## **Regional Municipality of Durham**

### **Bid Opportunity: T-1160-2021 – Construction of New Seaton Paramedic Station and Training Facility in the City of Pickering**

#### **Addendum Number 03 – December 17, 2021**

4. 1/A-923 Enlarged Plan

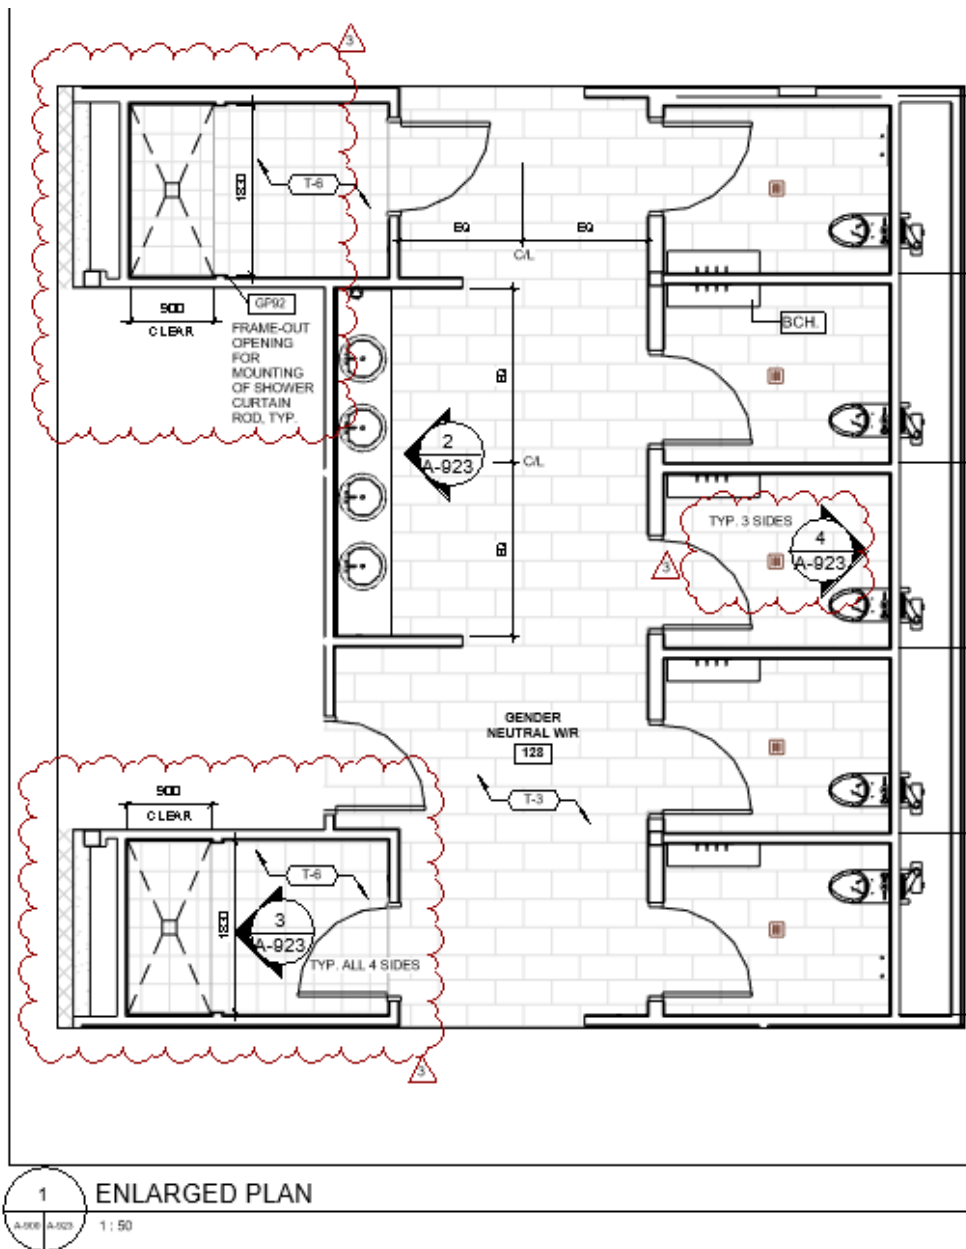
1. Added GP92 to frame shower opening for mounting of shower curtain rod.
2. Added floor drains in both shower rooms.
3. Clarified which walls to receive tile in shower rooms and toilet rooms.

**3.7 Washroom and custodial accessory - quantity and location schedule**

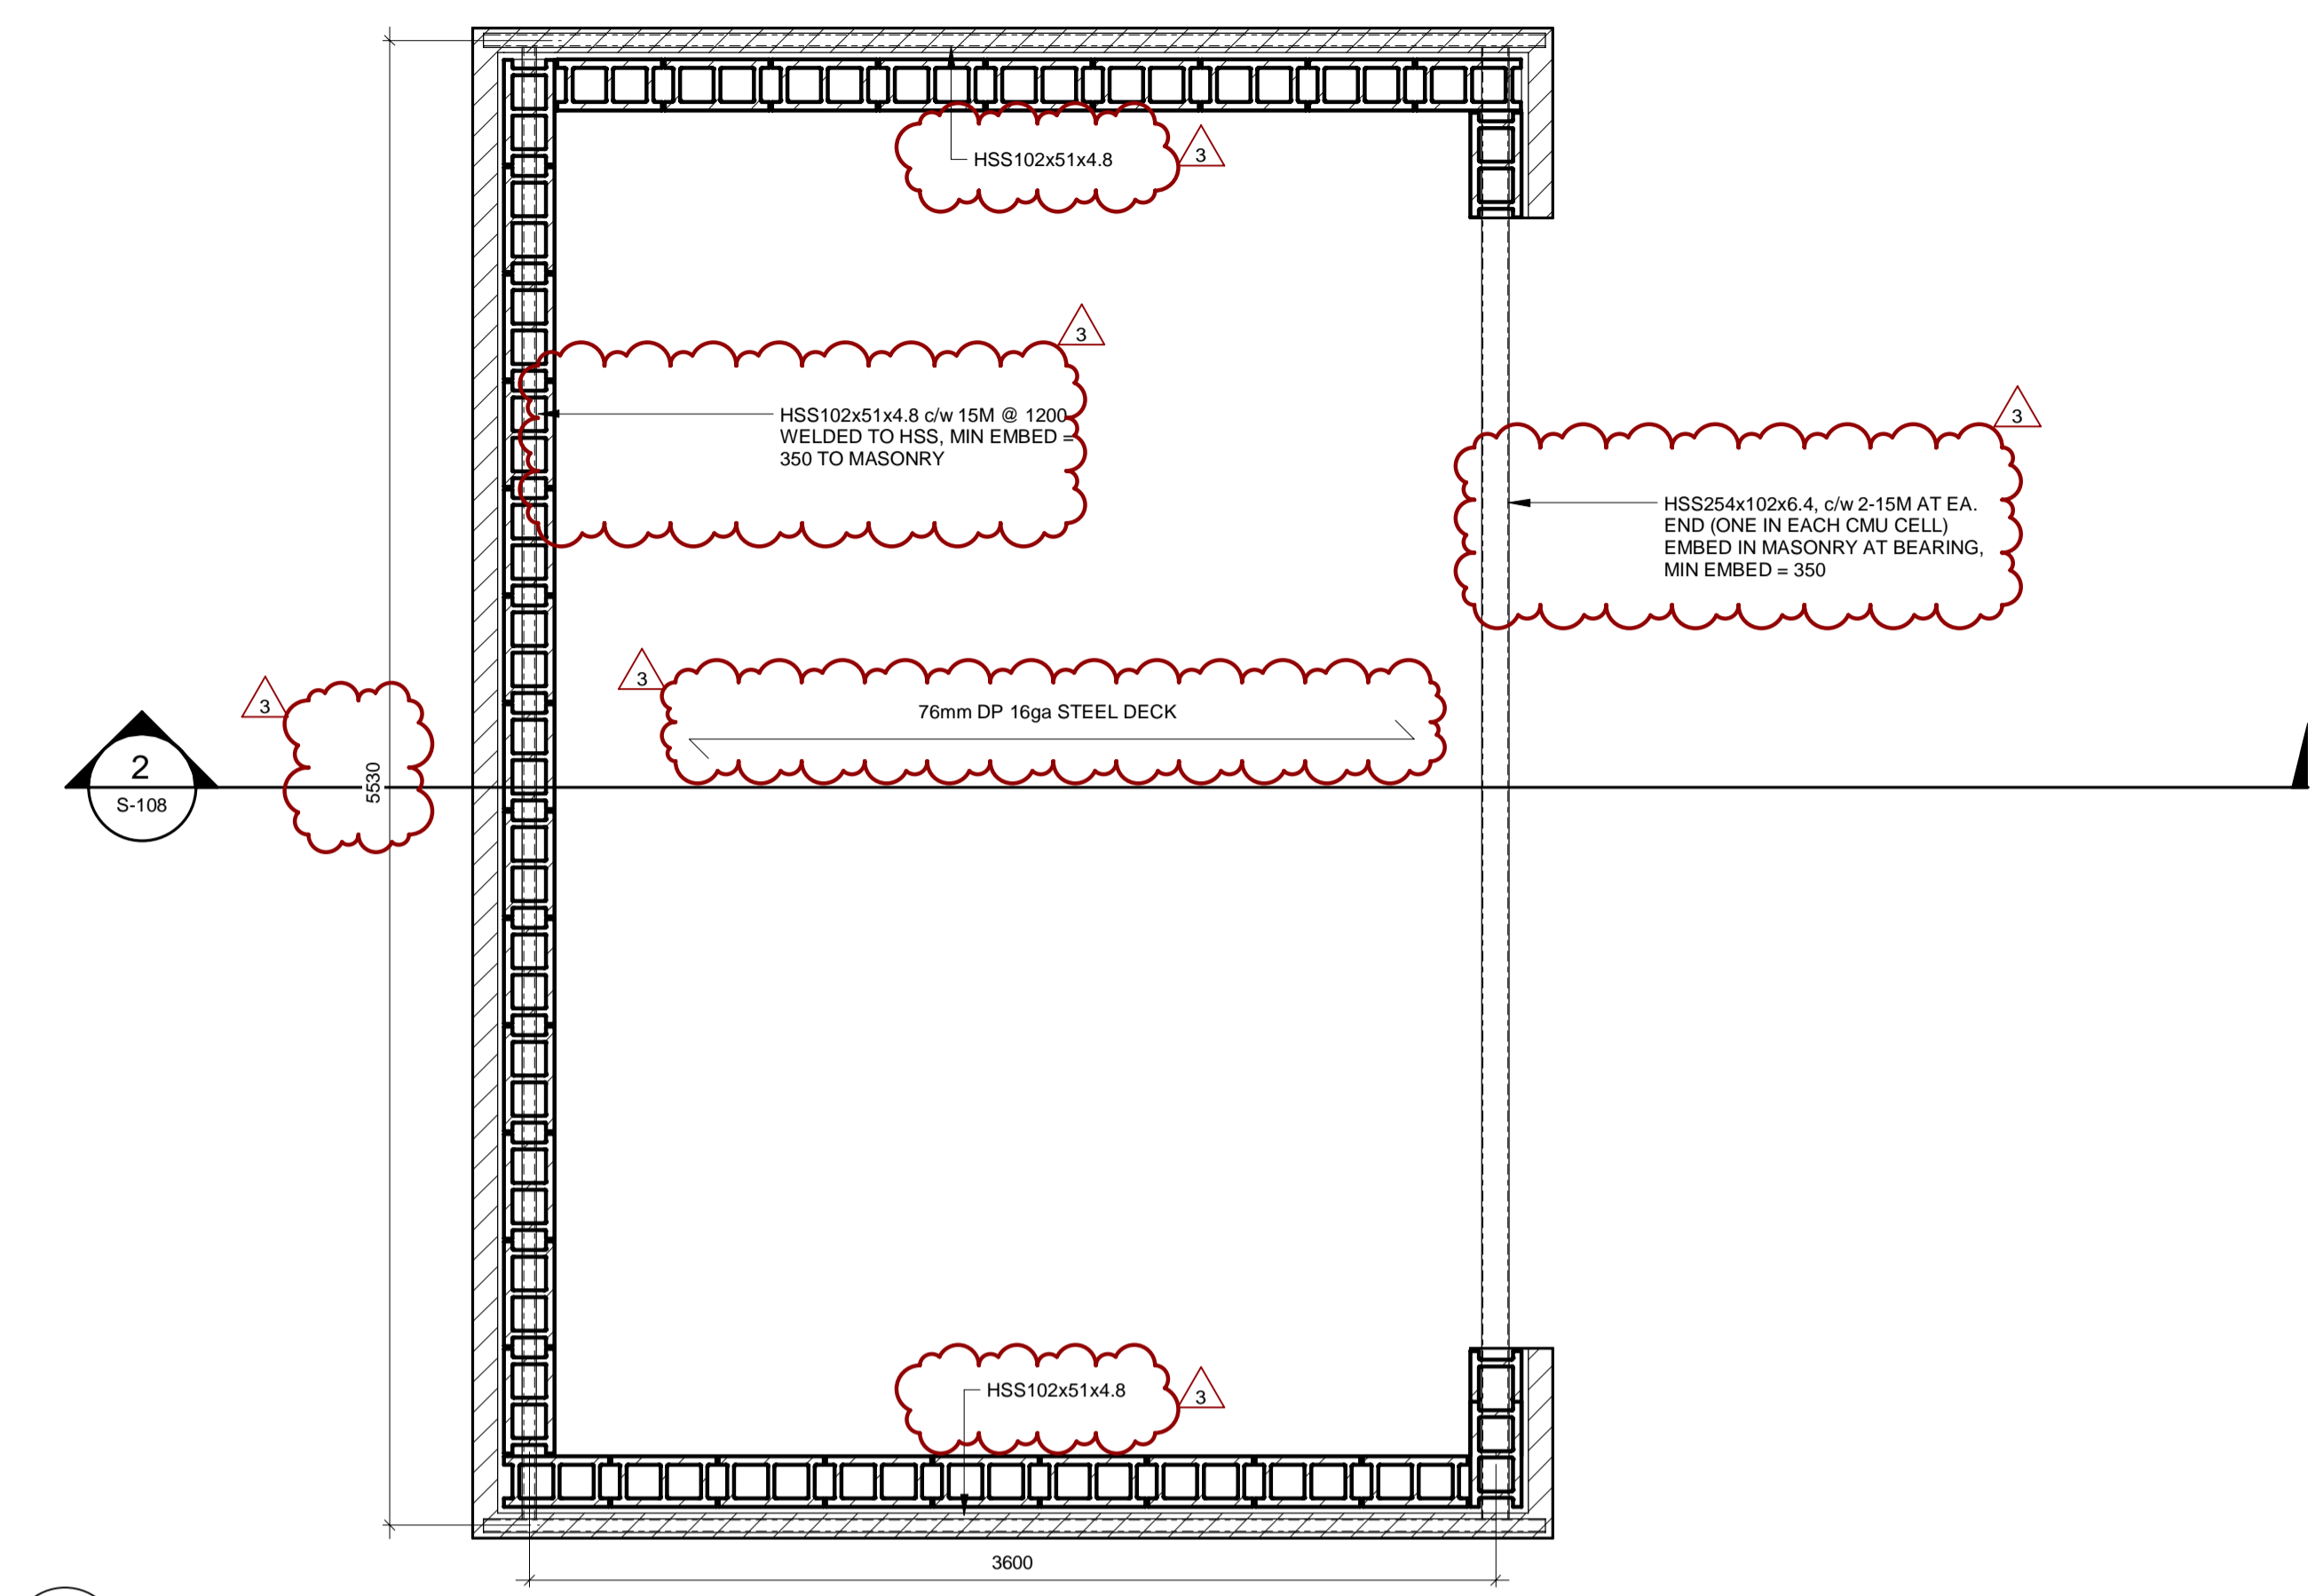
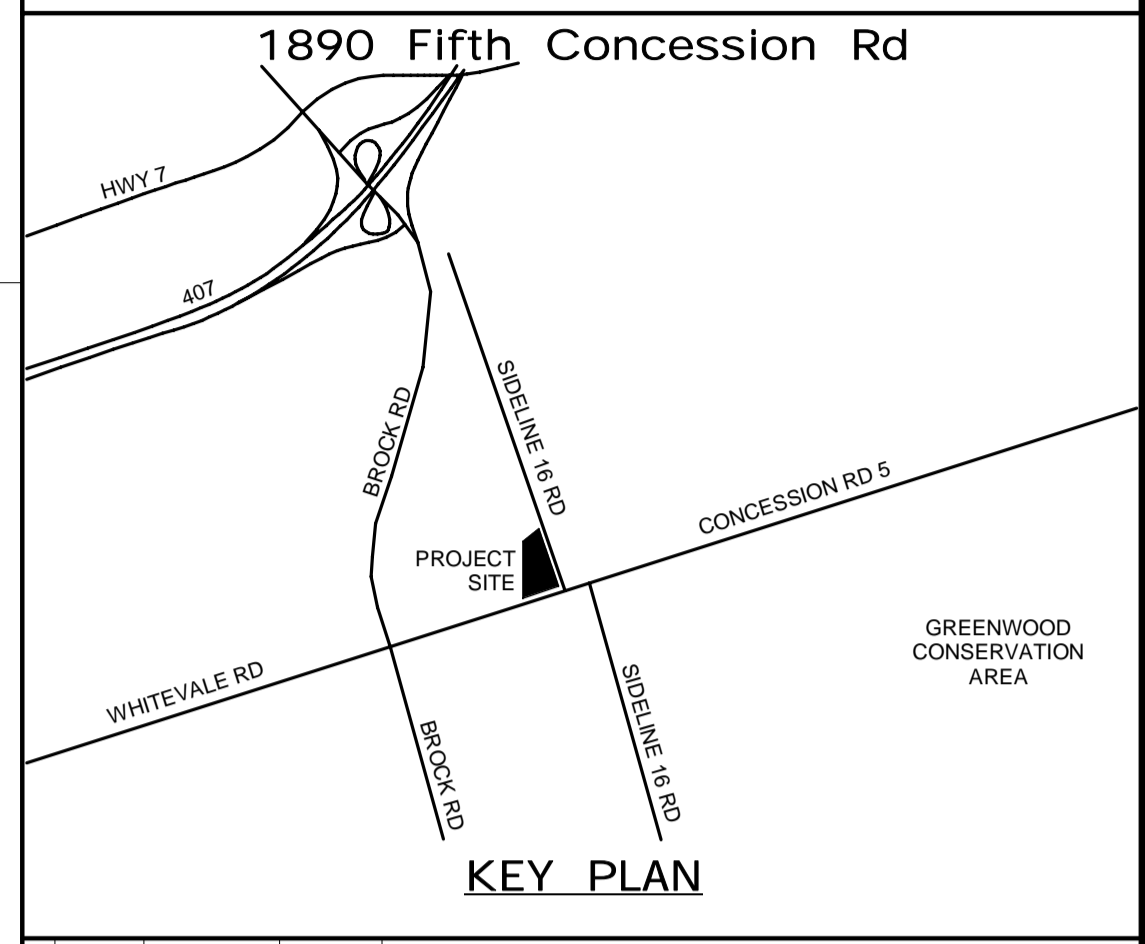
1. Section 10 22 26 Operable partitions
  1. Deleted pass door.
  2. Changed pocket door type to Type III.
  3. Provided panel finishes.
2. Section 10 28 13 Washroom accessories
  1. Revised 3.5 Washroom and custodial accessory schedule.
  2. Added 3.7 Washroom and custodial accessory - quantity and location schedule.

Washroom accessories 10 28 13. Specification product schedule shows a large quantity of accessories that are not located on drawings. Please provide a schedule that matches drawings.

See revised 10 28 13 Washroom accessories, issued as part of this Addendum 03.

NEW PARAMEDICS STATION - SEATON  
DETAILS SHEET 7 OF 7

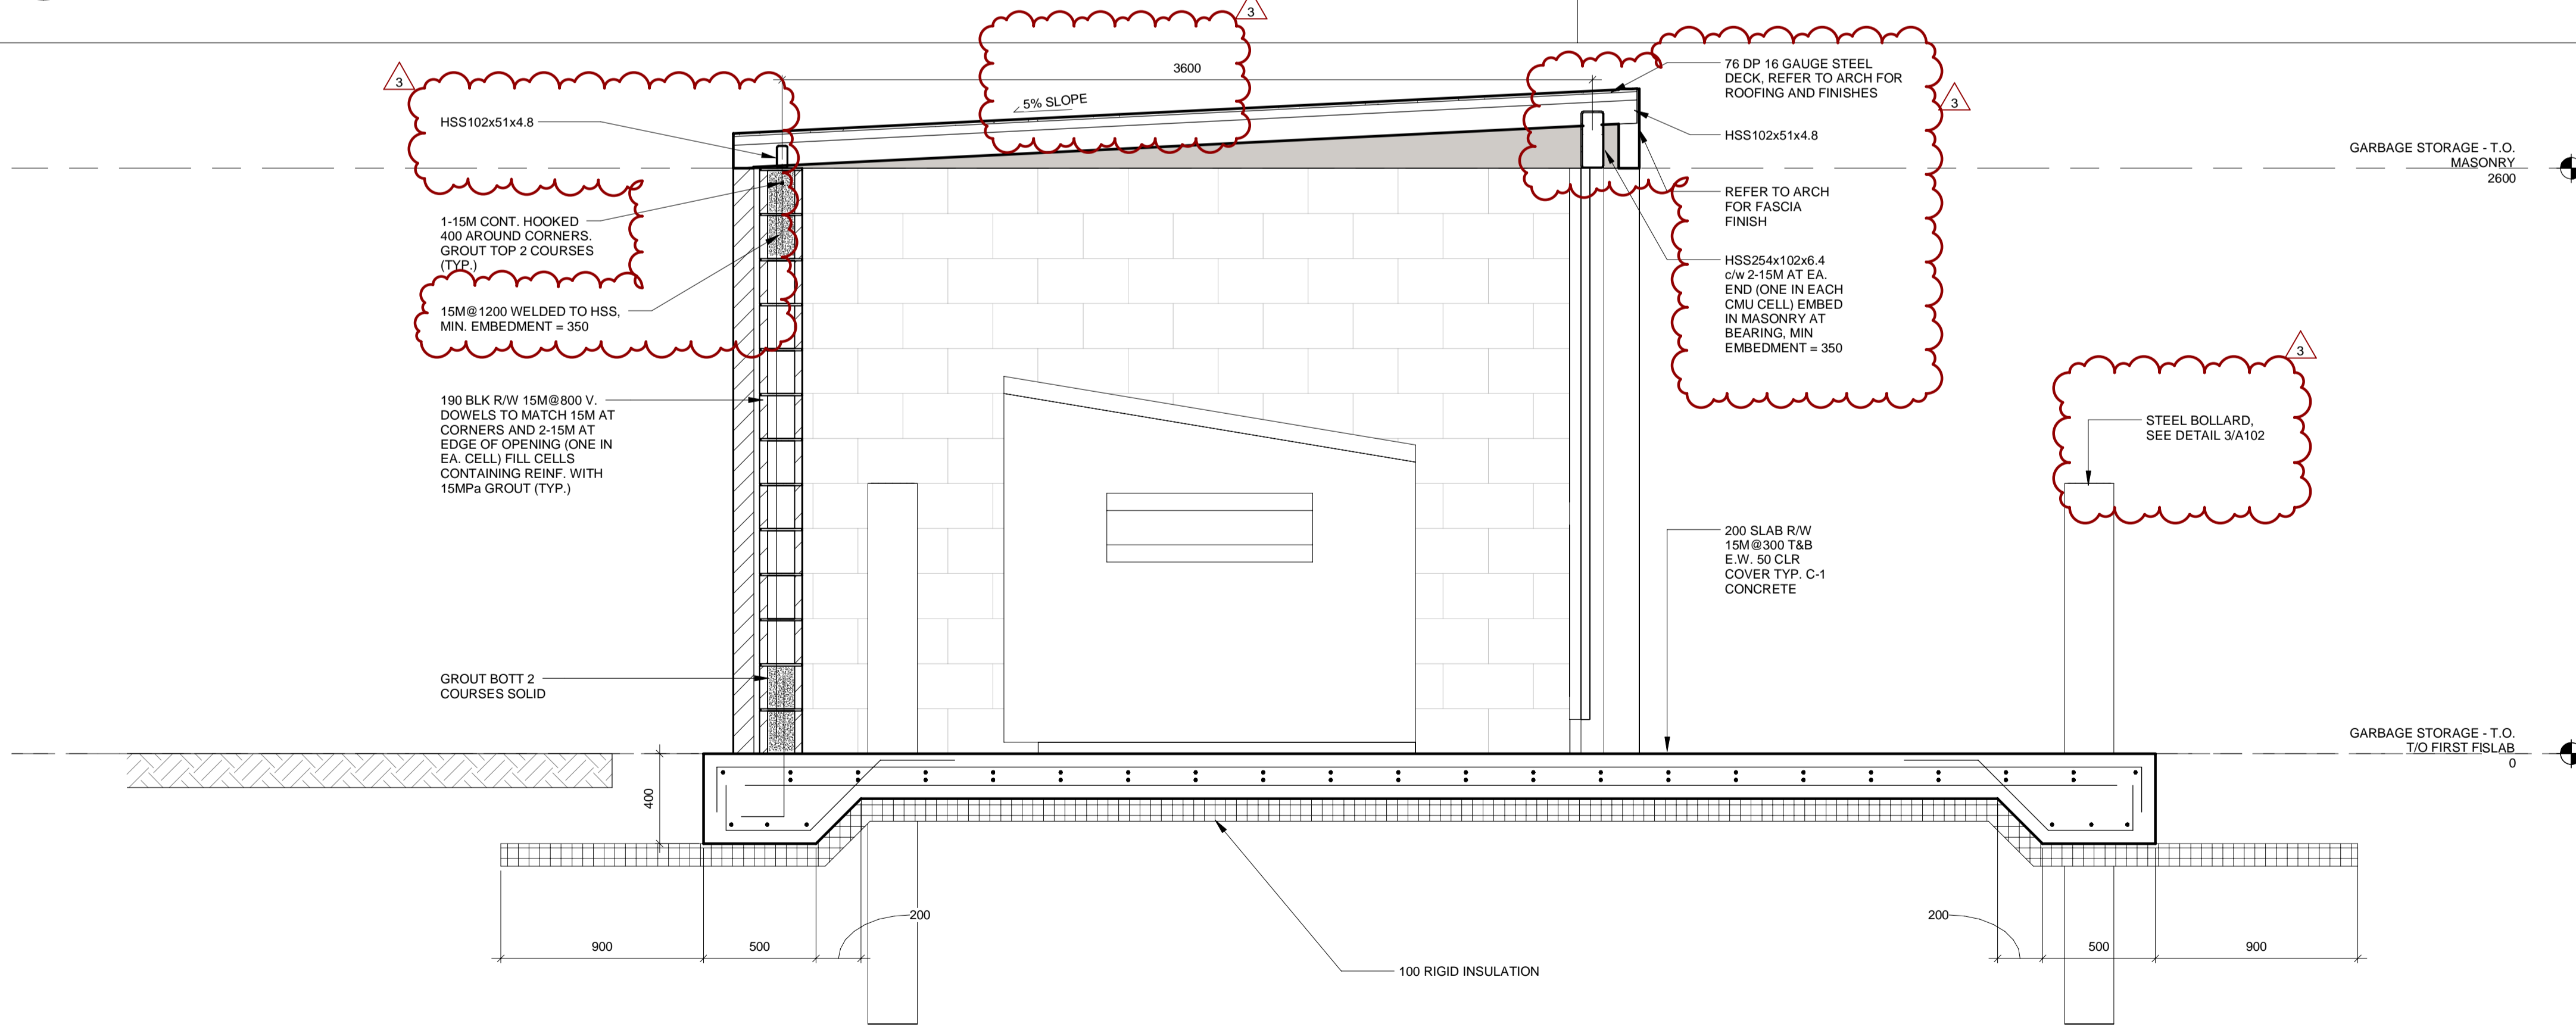
1. S-108 Details Sheet 7 of 7 (attached in this Addendum)
  1. Additional structural information for garbage enclosure.
2. S-200 Foundation Plan (attached in this Addendum)
  1. Missing footing reinforcement information provided.
3. 1/A-203 Enlarged Main Washroom Plan
  1. Added dimension for openings inside Decon 130.

Referencing to drawing 5/A-103 for garbage enclosure detail shows 300 thick reinforced slab. And drawing 2/S-108 showing 200 thick reinforced slab. Please confirm which drawing to follow.

Drawing 2/S-108 will govern.
